APPLICATION NO.	FILING DATE	FIRST NAMED INVENTOR	ATTORNEY DOCKET NO.	CONFIRMATION NO.
10/551,354	06/21/2006	Paul R. Smith	593458001US	6414
25996 7590 08/06/2008 PERKINS COIE LLP PATENT-SEA P.O. BOX 1247 SEATTLE, WA 98111-1247				
EXAMINER				
CHARLES, MARCUS				
ART UNIT		PAPER NUMBER		
3682				
MAIL DATE		DELIVERY MODE		
08/06/2008		PAPER

Office Action Summary

DETAILED ACTION

FIG 2

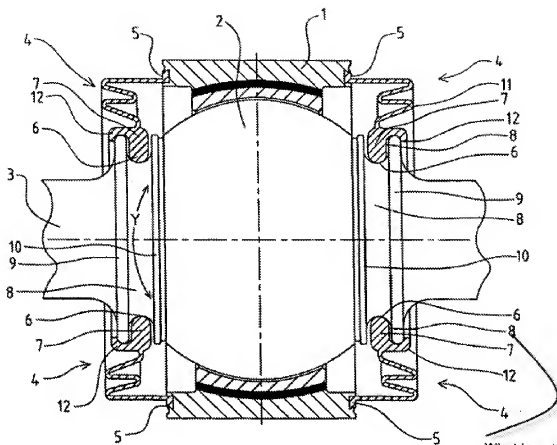
In addition, in figures 2 and 3, it is not clear as to what the reference "8" (the upper and lower right side) is depicting. Note the drawing illustration below only depict "8" at the lower right side.

What is
this?
